Technical Service Bulletin

46 A6 and A7 squealing from front brakes (PR-1LJ)

46 15 14 2040964/1 June 29, 2015.

Model(s)	Year	VIN Range	Vehicle-Specific Equipment
A6, A7	2014	000001 - 047382	PR 1LJ

Figure 2. Front brake disc part number location.

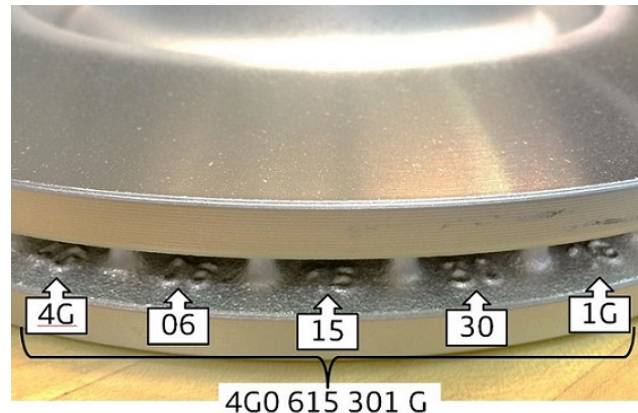
Check the part number on the front discs. If part number is not 4G0615301G, then install 4G0615301G front discs (Figure 2).
